Public Service
Electric and Gas
Company

ELIMINATION OF ARBITRARY INTERMEDIATE PIPE BREAKS
HOPE CREEK GENERATING STATION
DOCKET NO. 50-354

Public Service Electric and Gas Company (PSE&G) requests approval for the Hope Creek Generating Station (HCGS) to eliminate the postulation of intermediate pipe breaks as specified by Standard Review Plan (SRP) 3.6.2 Sections II.1 and II.2 for the Main Steam system and Reactor Water Cleanup (RWCU) system inside containment unless such locations exceed the stress and usage factor threshold levels provided in Branch Technical Position (BTP) MEB 3-1 or are located in the proximity of welded pipe attachments.

HOPS CREEK GENERATING STATION FINAL SAFETY ANALYSIS REPORT
MAIN STEAM PIPING ISOMETRIC (PORTION INSIDE PRIMARY CONTAINMENT)
FIGURE 3.6.2 SHEET 1 OF 2
AMENDMENT 6 OF 94

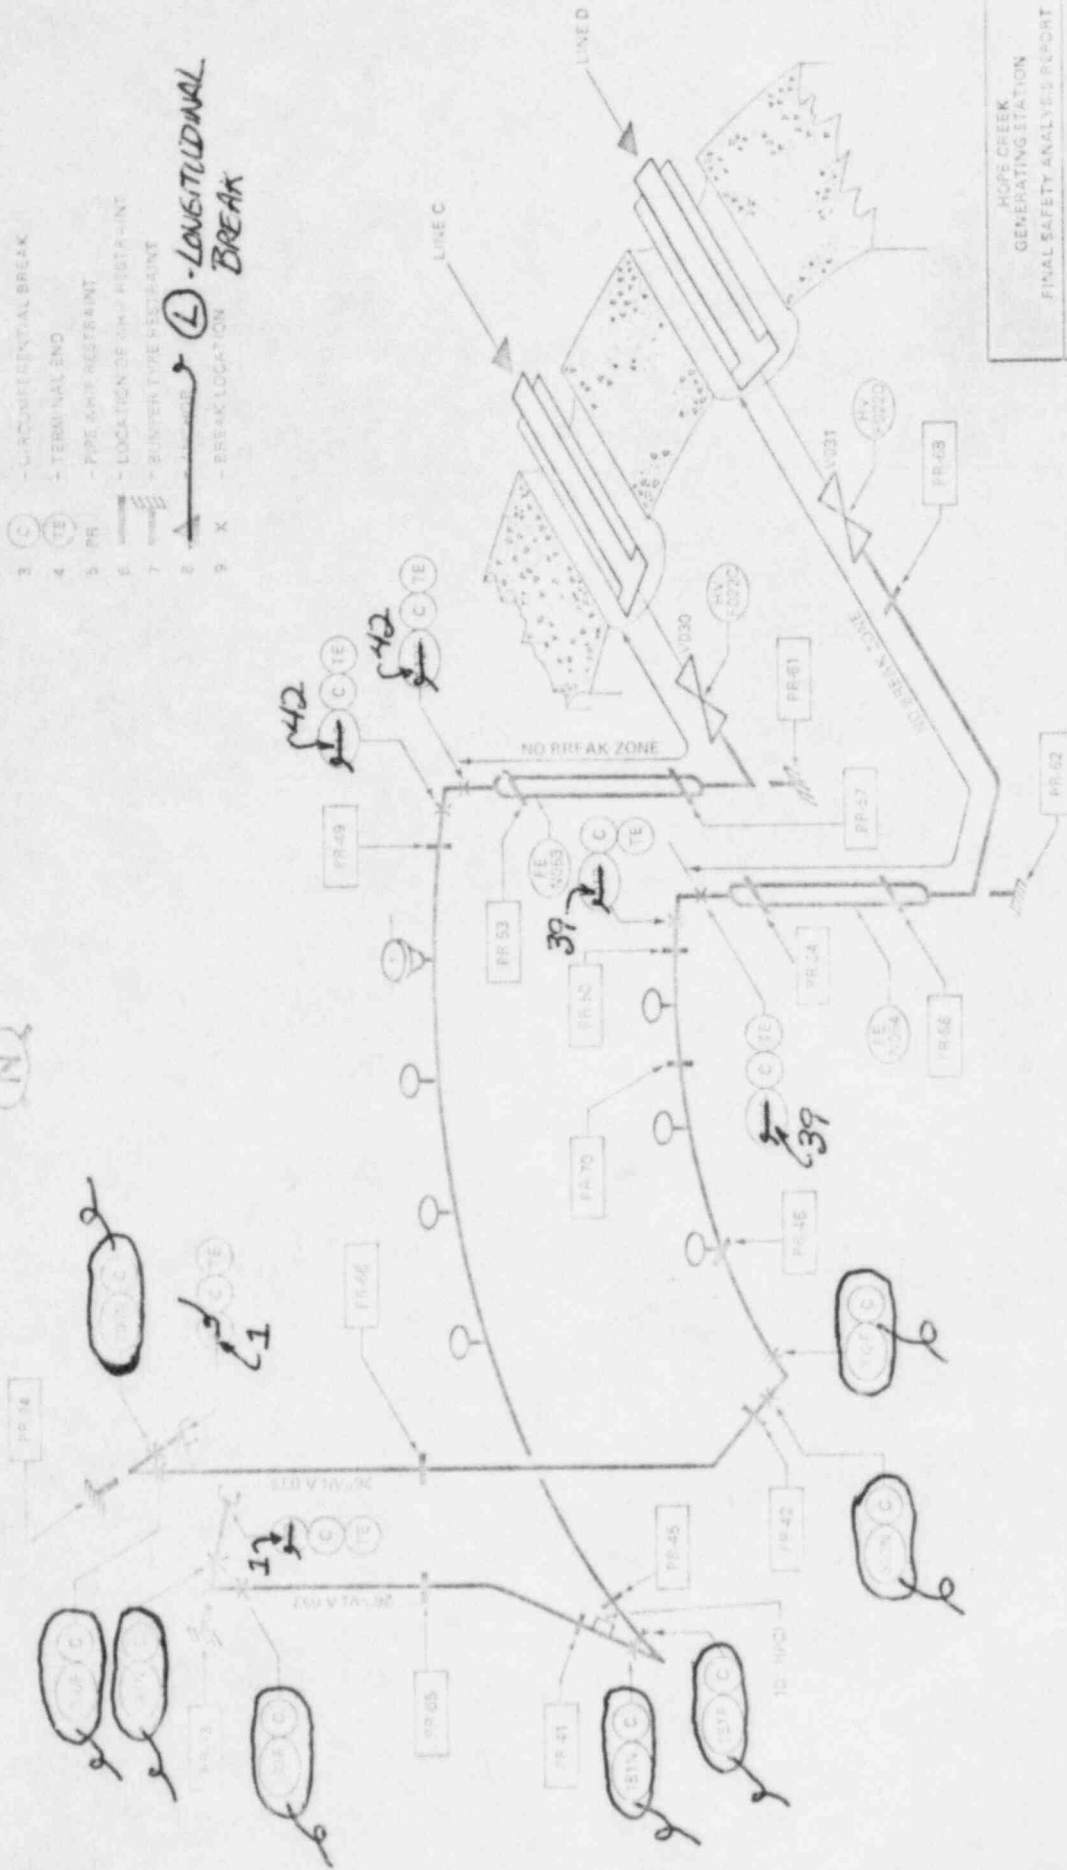
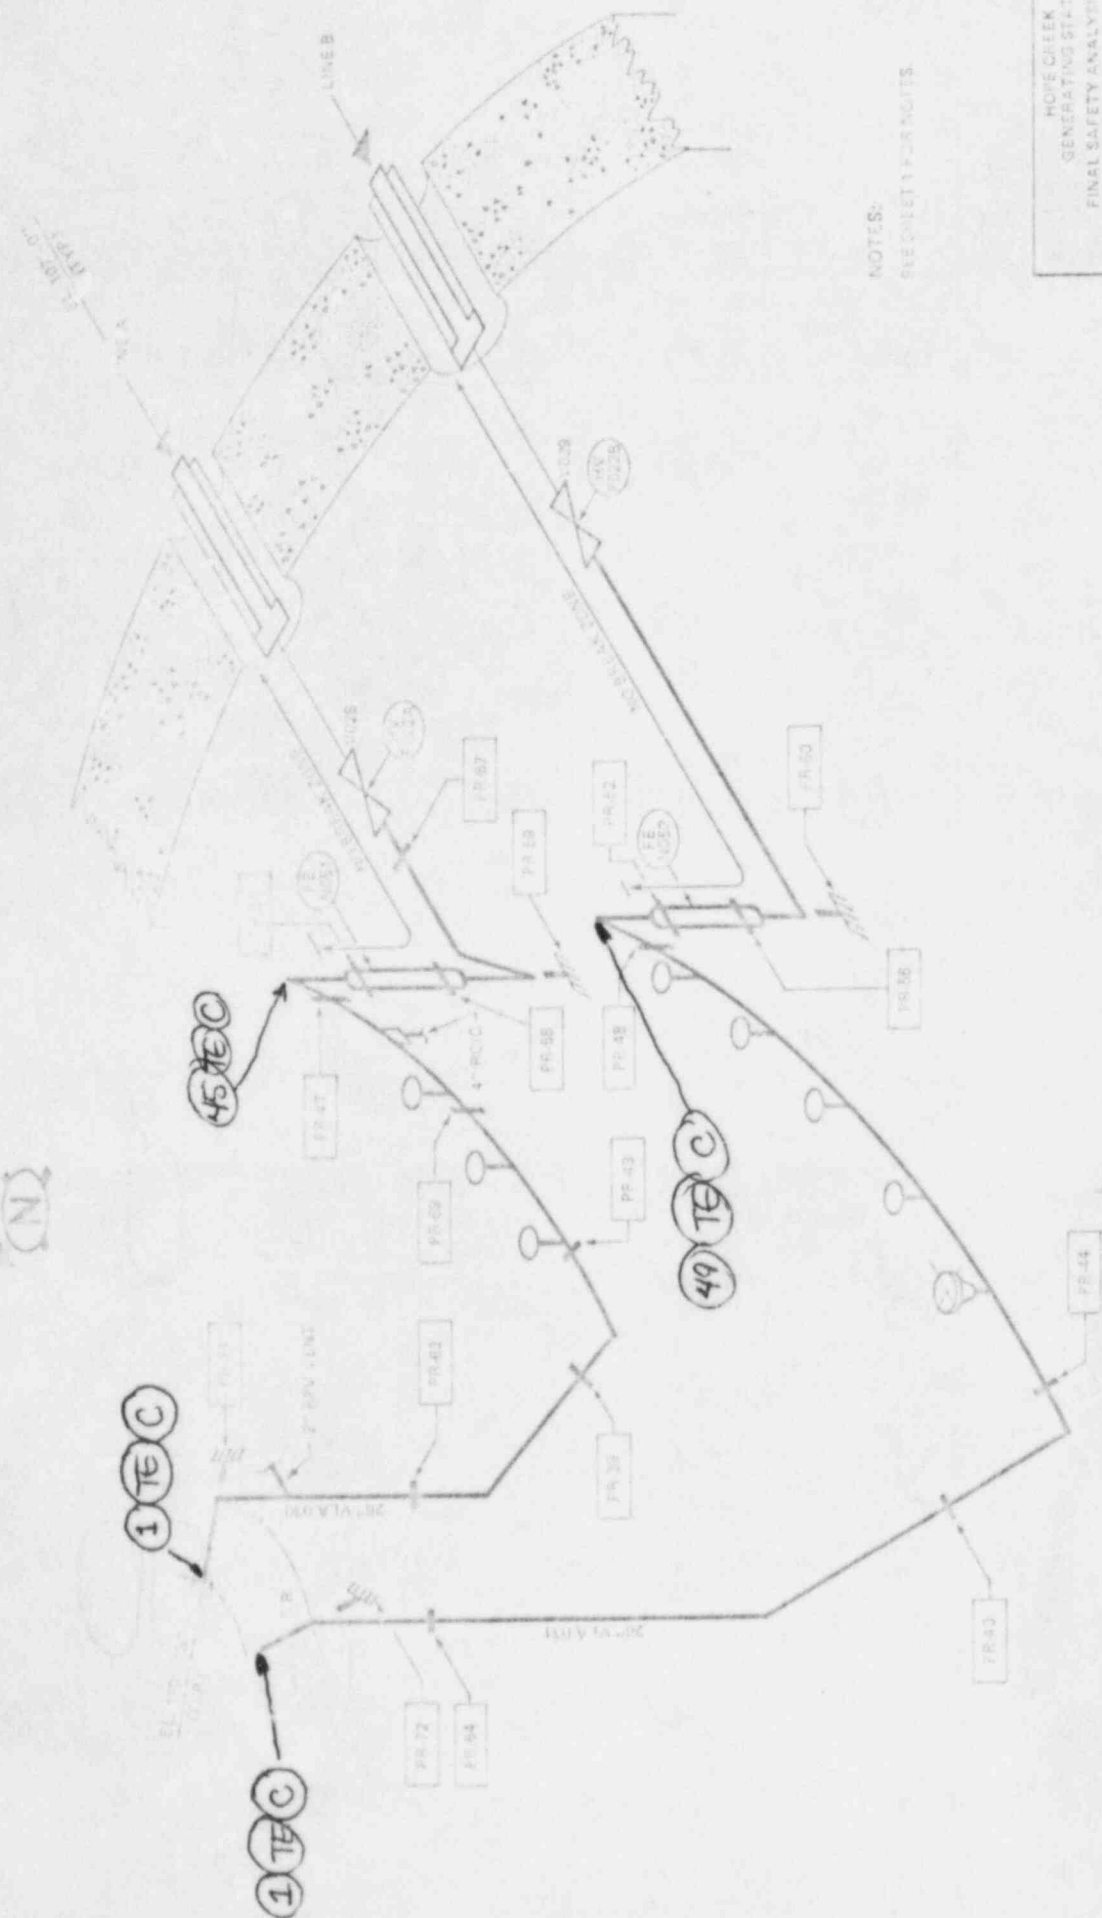
~~PRELIMINARY~~ MAIN STEAM SYSTEM PIPING STRESS LEVELS
AND PIPE BREAK DATA
(PORTION INSIDE PRIMARY CONTAINMENT)

~~MBL - Intermediate break locations selected to satisfy the requirements for a minimum number of break locations.~~

INSERT A

Line A

1	TTJ	29.94	0.010	42.5	C	TE
45	EL	62.07*	0.02*	42.5	C	TE

Line B

1	TTJ	24.95	0.000	42.5	C	TE
49	EL	53.61*	0.02*	42.5	C	TE

Line C

1	TTJ	28.41	0.010	42.5	C	TE
42	EL	54.58*	0.010	42.5	C	TE

Line D

1	TTJ	27.9	0.010	42.5	C	TE
39	EL	61.95*	0.020*	42.5	C	TE

FIGURE 3.6-15

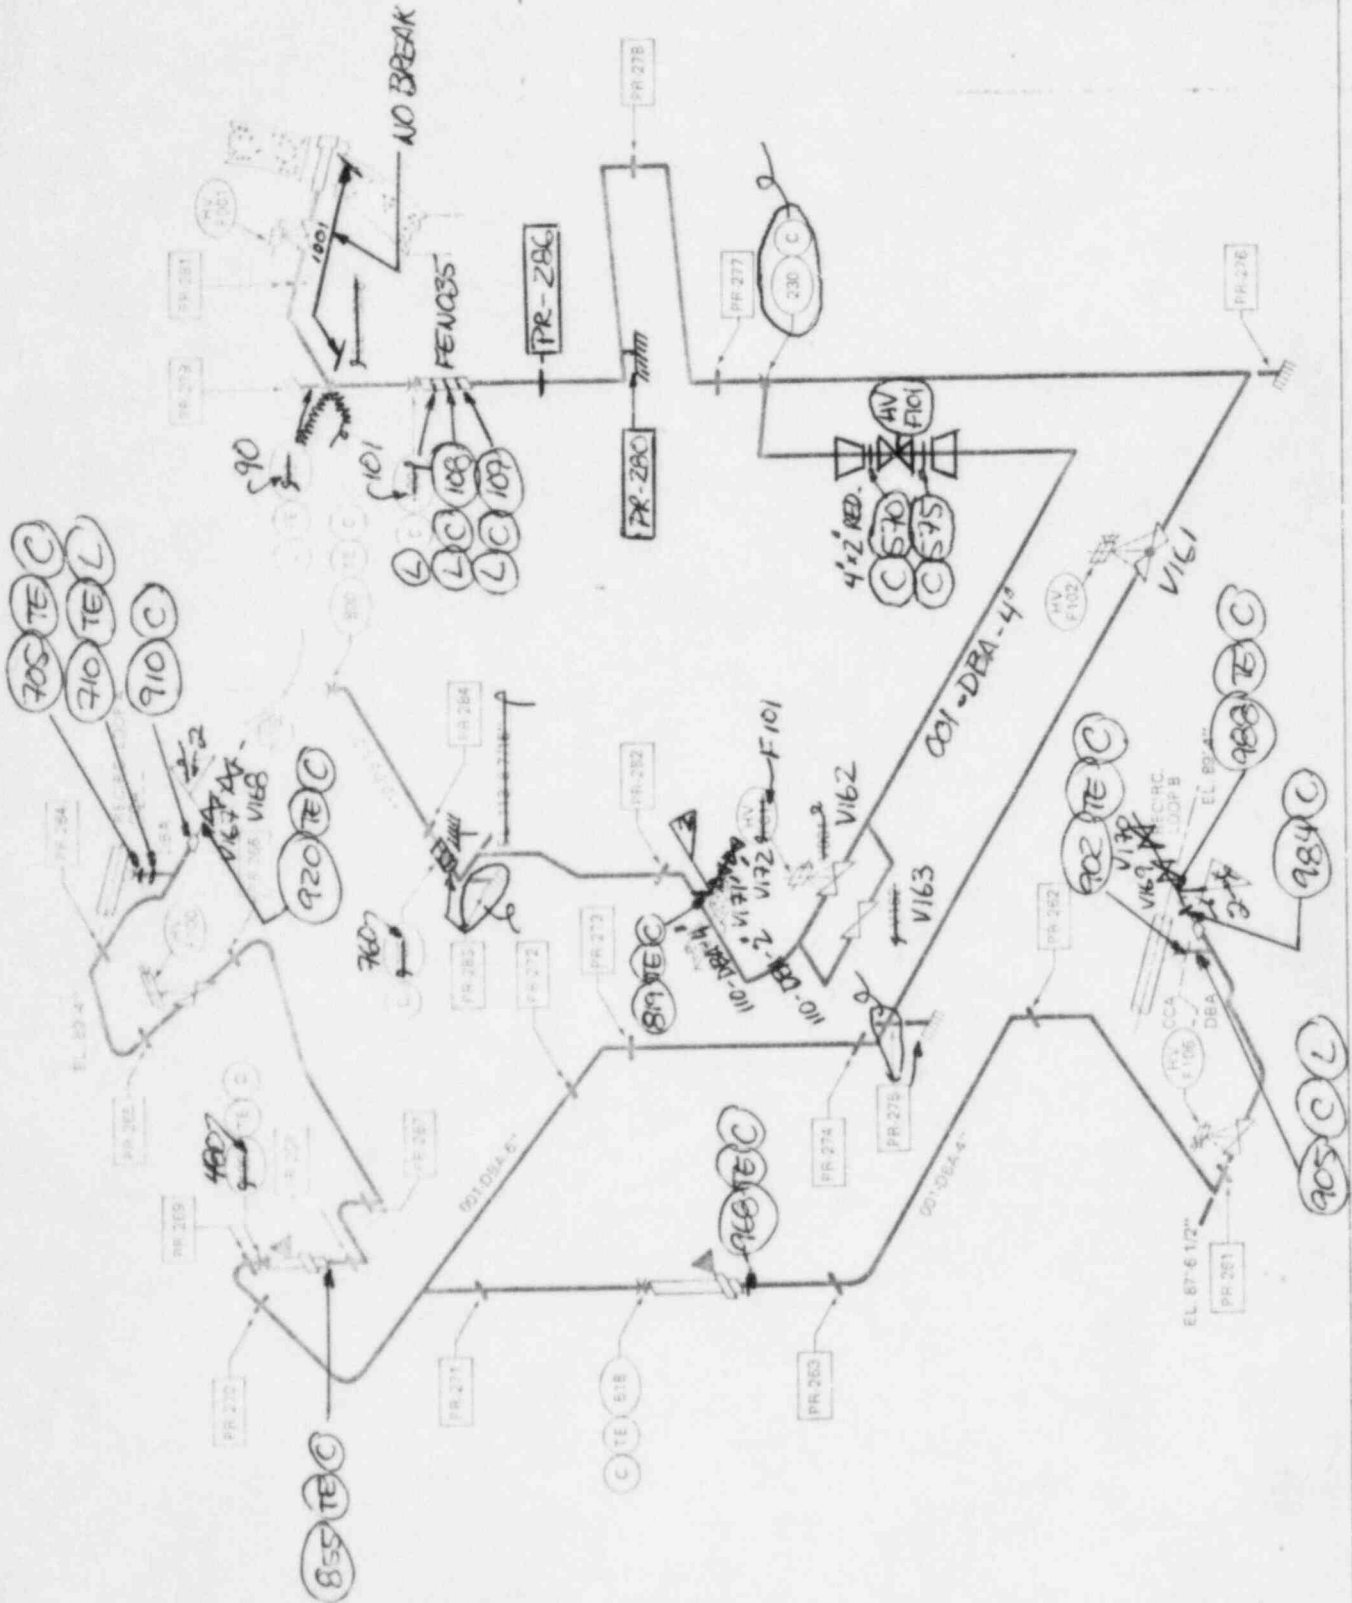
~~PRELIMINARY~~ ^{FINAL} RWC SYSTEM PIPING STRESS LEVELS AND PIPE BREAK DATA
(PORTION INSIDE PRIMARY CONTAINMENT)

DELETE
AND
REPLACE
WITH
INSERT
B

~~MBL - Intermediate break locations selected to satisfy
the requirements for a minimum number of break
locations.~~

INSERT B

90	BW	14.227	0.0001	43.60	C	TE
101	BW	68.251	0.8853	43.60	C&L	SFL
480	BW	10.344	0.0000	43.60	C	TE
518	BW	10.332	0.0000	43.60	C	TE
760	RED	65.771	0.125	43.60	C	SFL
800	BW	10.357	0.0002	43.60	C	TE
108	TTJ	76.297	0.5401	43.60	C&L	SFL
109	DSW	52.044	0.1346	43.60	C&L	SFL
570	SW	64.676	0.6697	43.60	C	SFL
575	SW	61.147	0.5535	43.60	C	SFL
819	SW	22.763	0.004	43.60	C	TE
705	TTJ	49.52	0.0139	34.64	C	TE
710	TTJ	75.508	0.862	34.64	C&L	SFL
910	RED	48.52	0.0152	43.60	C	SFL
920	SW	8.93	0.0003	43.60	C	TE
855	BW	12.67	0.0000	43.60	C	TE
902	TTJ	45.5	0.0085	34.64	C	TE
905	TTJ	78.52	0.921	34.64	C&L	SFL
984	RED	48.52	0.0152	43.60	C	SFL
988	SW	9.01	0.0003	43.60	C	TE
968	BW	10.10	0.0000	43.60	C	TE
